PROPERTY ADDRESS: Grandin Road, West 4th Street and South Summit Avenue

SUMMARY OF REQUEST: COA revision for non-traditional material

Charlotte Historic District Commission - Case 2016-085
HISTORIC DISTRICT: WESLEY HEIGHTS

Grandin Heights Community
F.K.A. Grandin Road / W. 4th Street
Townhomes

1 Wall Section @ Typical Living Room / Master Bedroom
1/2" = 1'-0"

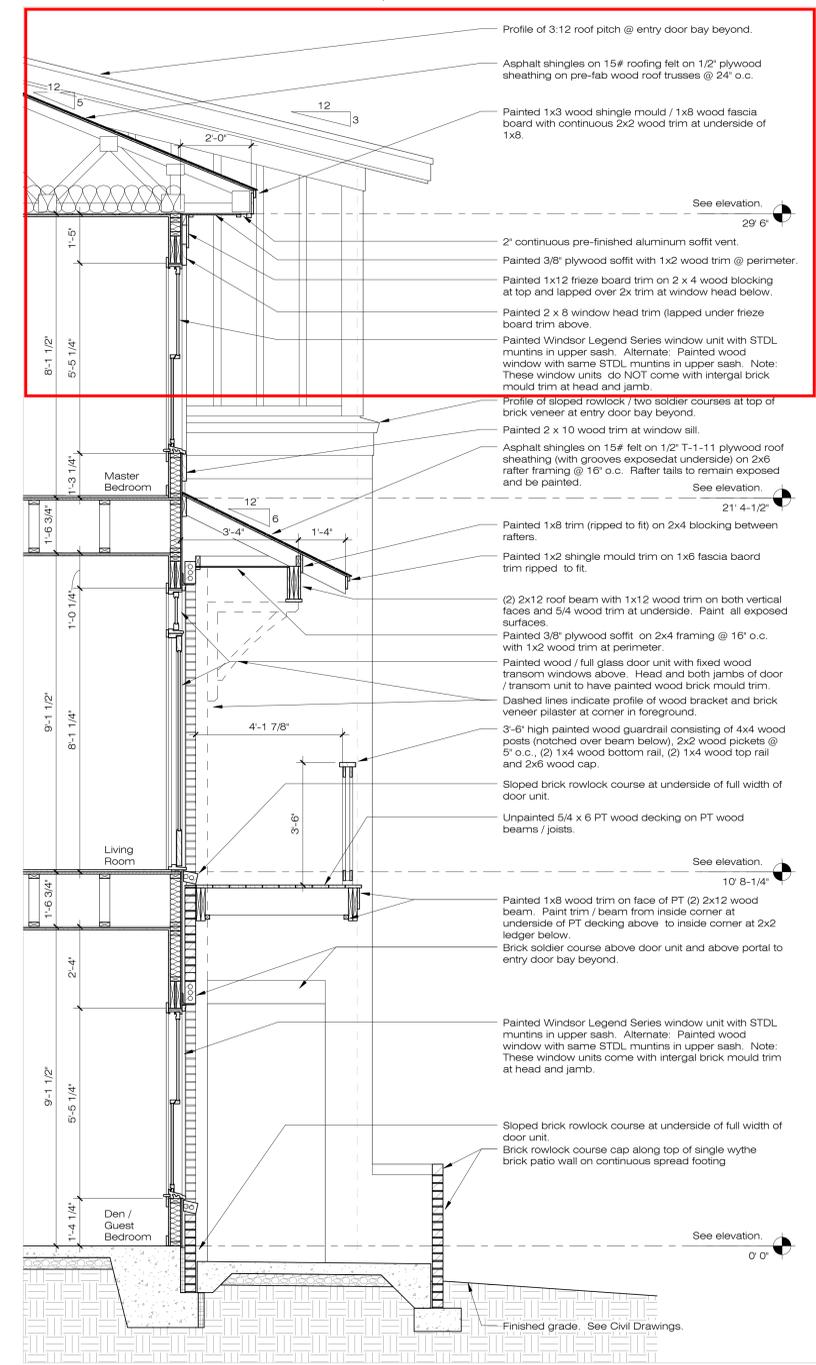
Attached Detail #1 (11" x 17" format) represents an enlarged view of this section of the approved wall section. Attached Detail #2 (also 11" x 17" format) represents the proposed new detail at this same location incorporating the non-combustible soffit material required by the NC Residential Code to minimize the risk of fire by-passing the 2-hour fire walls separating adjacent units.

2 Grandin Heights Townhomes - Proposed Third Floor Soffit Detail
1 1/2" = 1'-0"

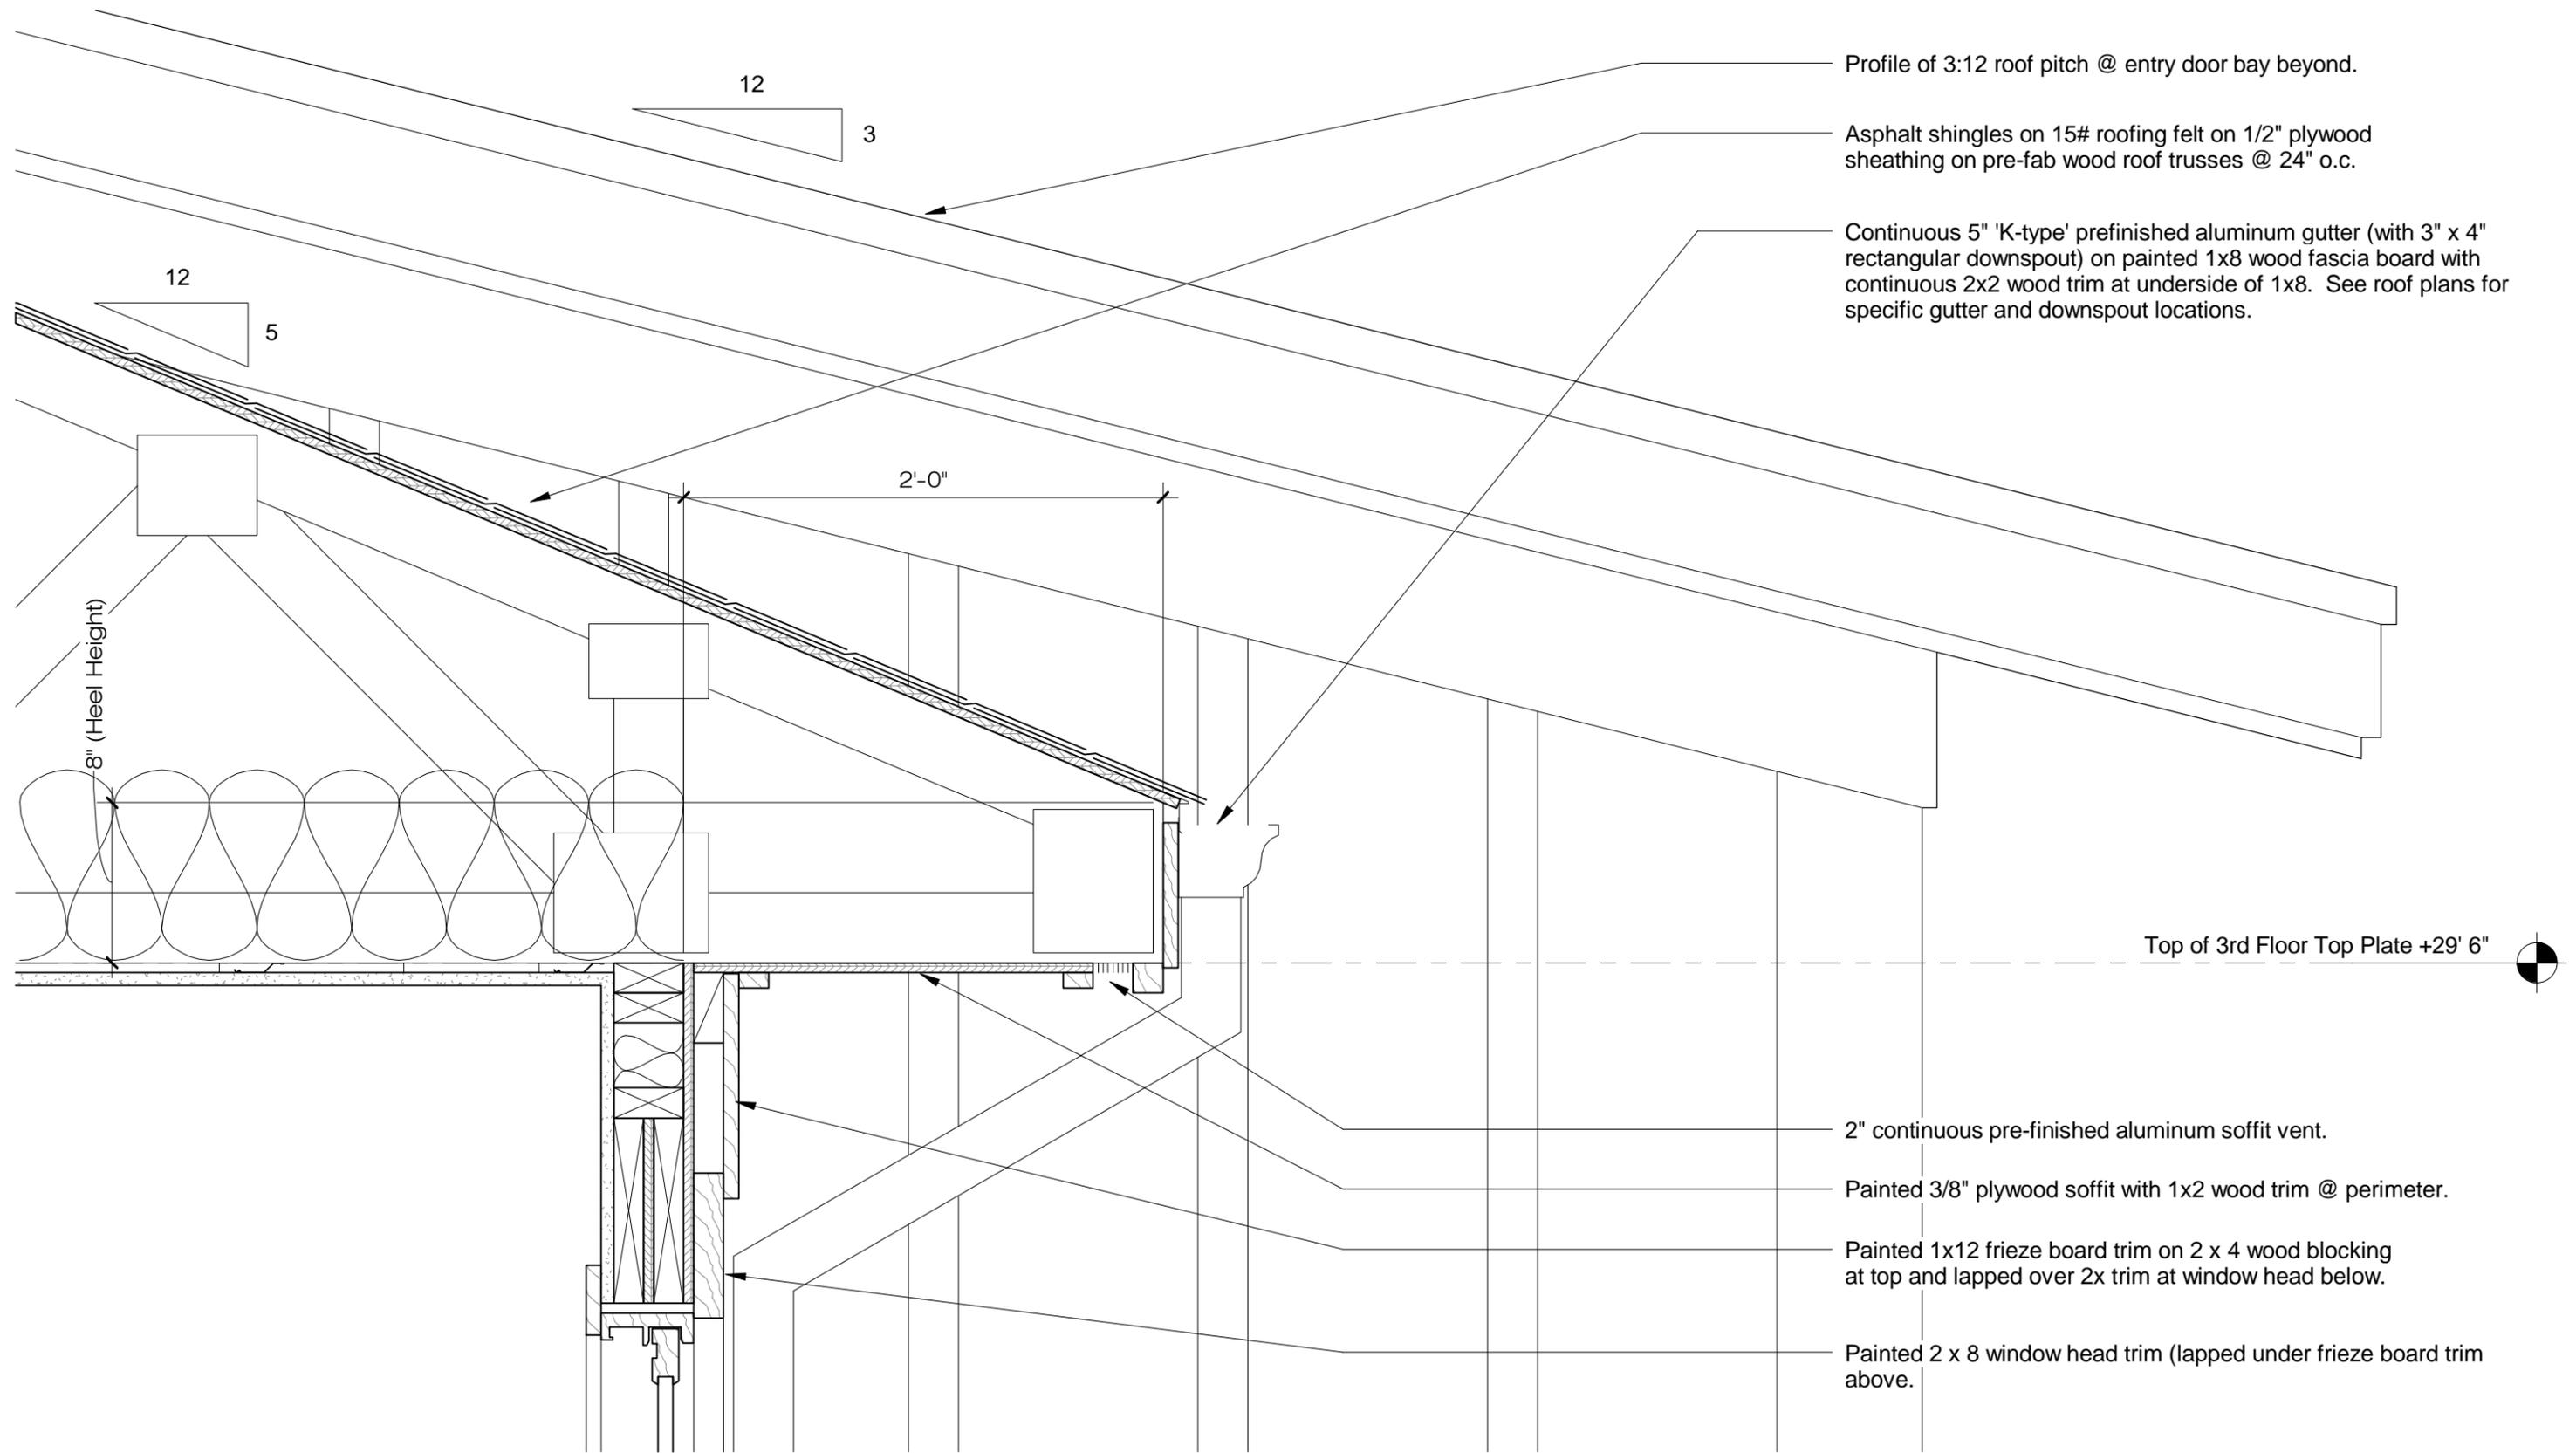
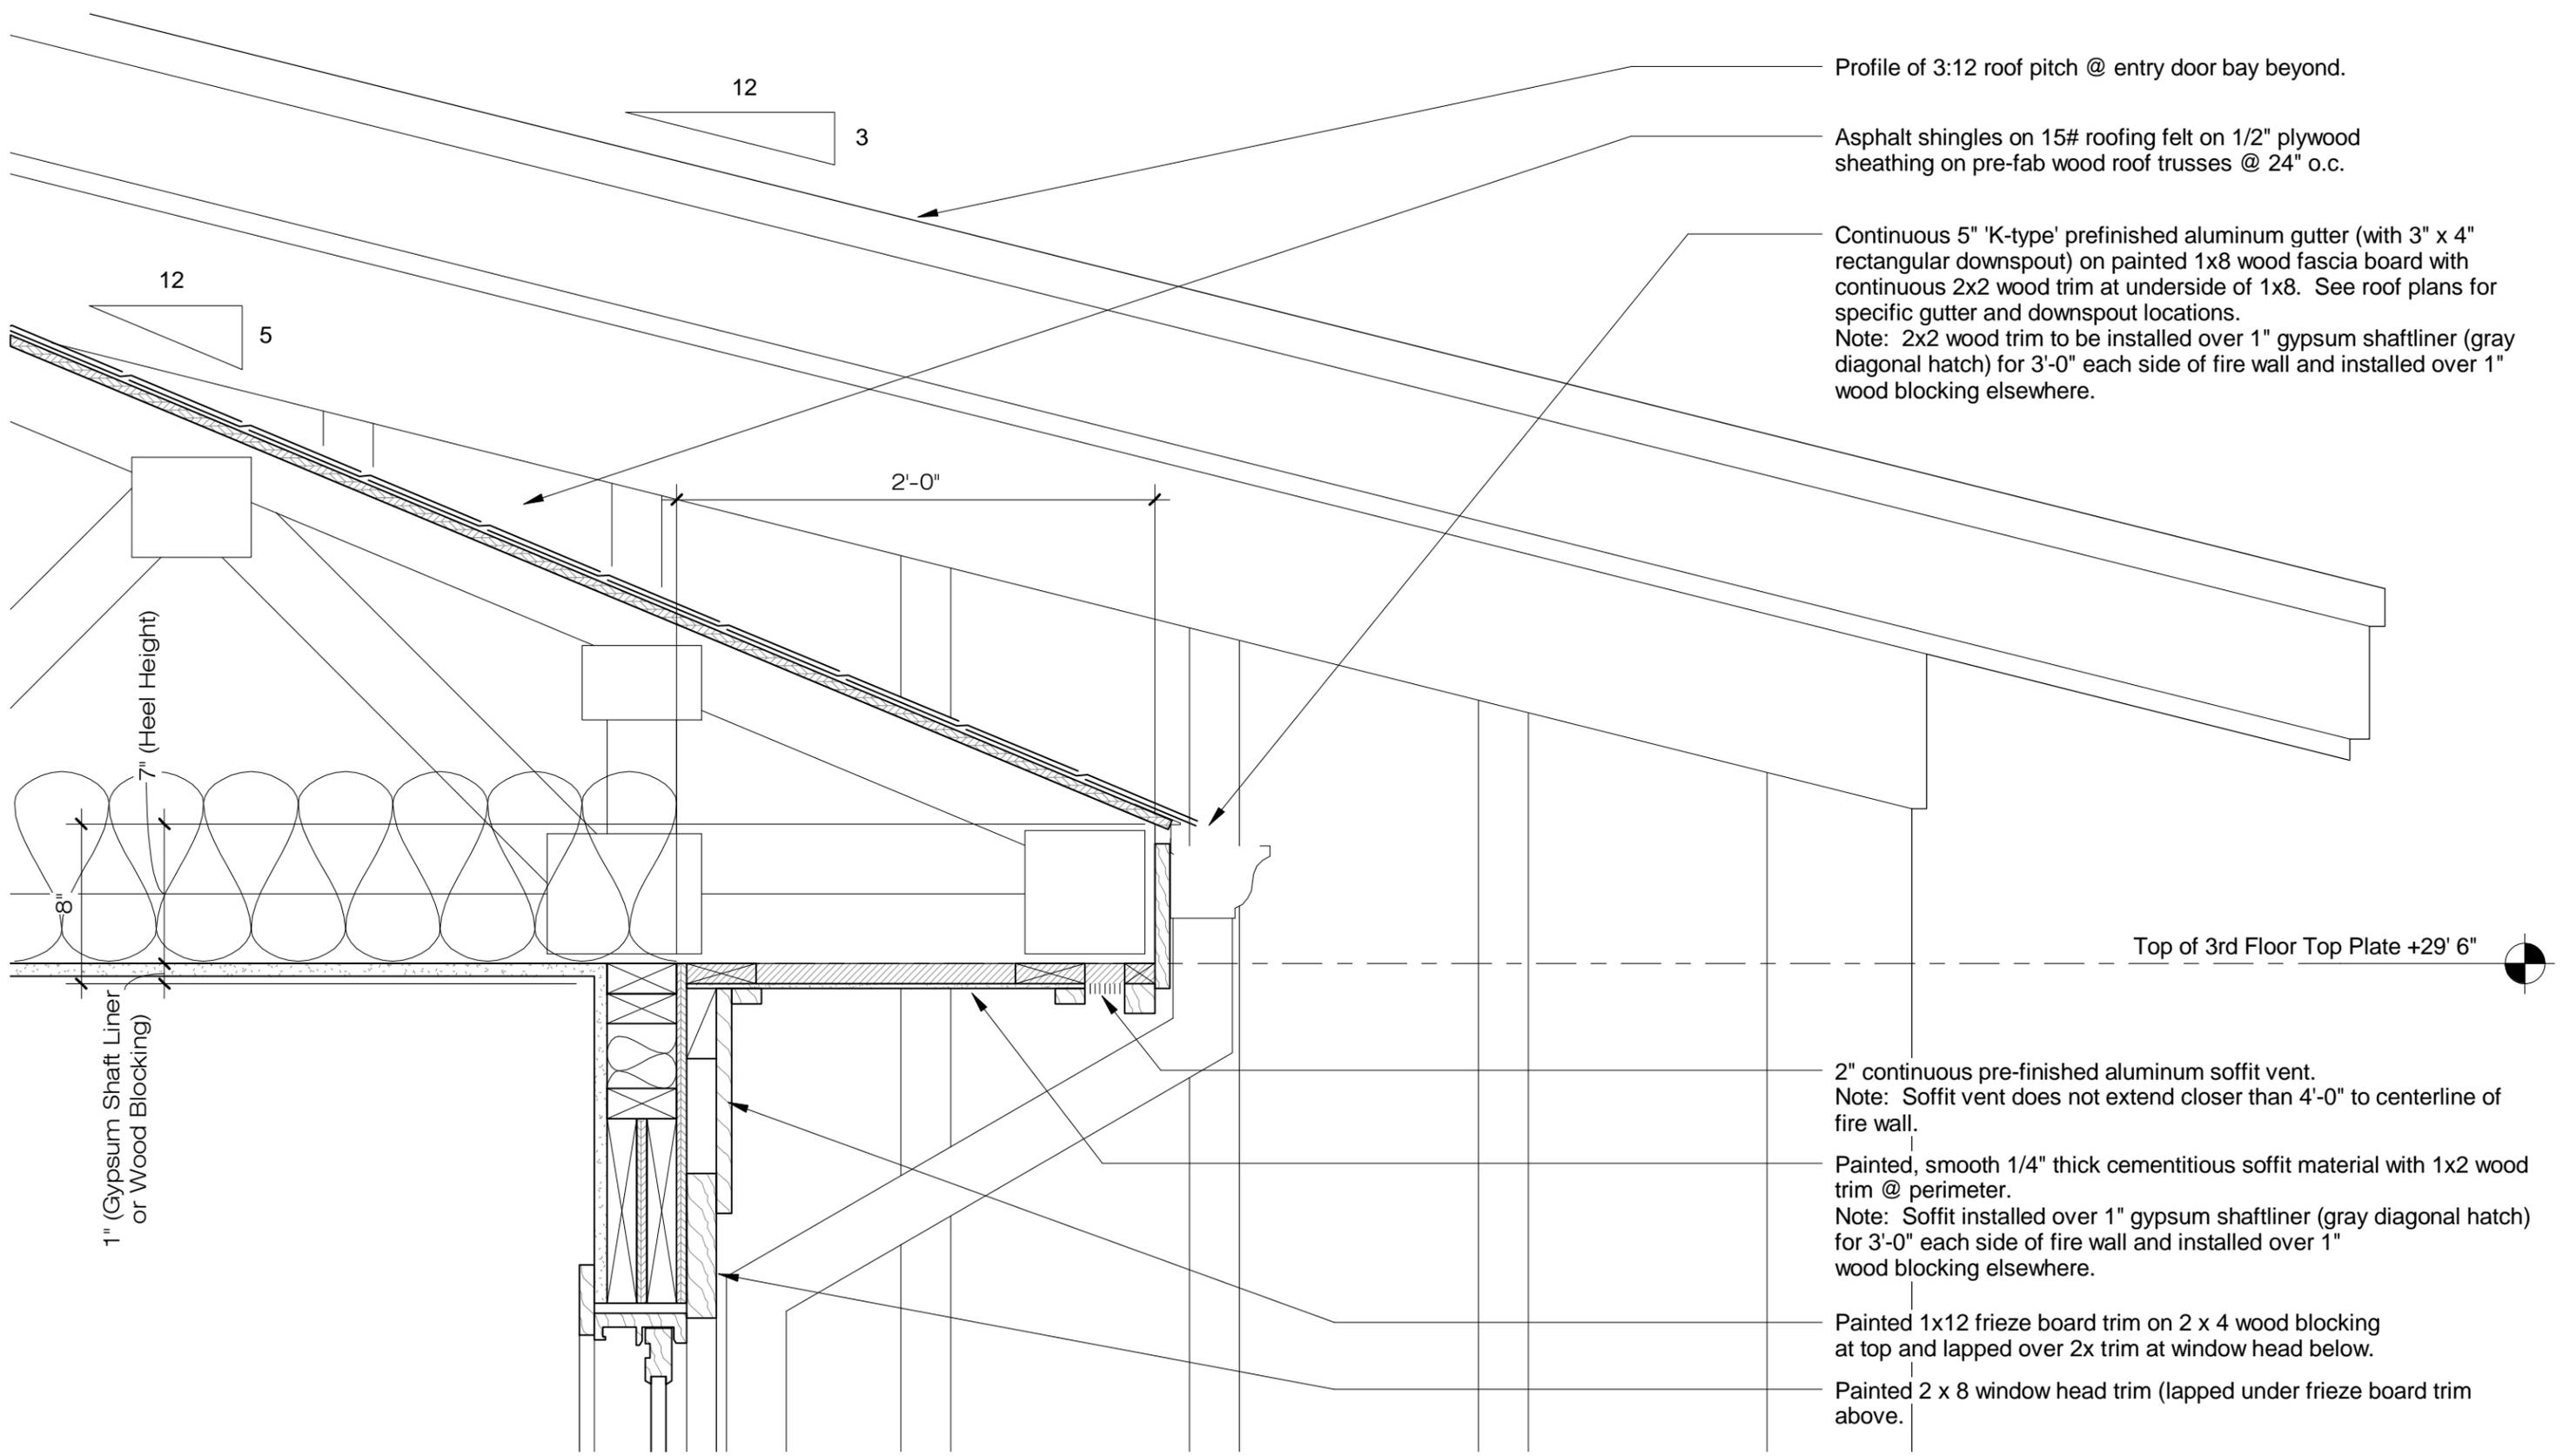
Note: 2x2 wood trim to be installed over 1" gypsum shaftliner (gray diagonal hatch) for 3'-0" each side of fire wall and installed over 1" wood blocking elsewhere.

2" continuous pre-finished aluminum soffit vent.
Note: Soffit vent does not extend closer than 4'-0" to centerline of fire wall.

Painted, smooth 1/4" thick cementitious soffit material with 1x2 wood trim @ perimeter.
Note: Soffit installed over 1" gypsum shaftliner (gray diagonal hatch) for 3'-0" each side of fire wall and installed over 1" wood blocking elsewhere.

This applicant is requesting approval for non-combustible materials on the third floor soffits to meet the North Carolina building code for commercial structures. A similar application for non-traditional material on a commercial building was approved February 10, 2016 (2015-287).
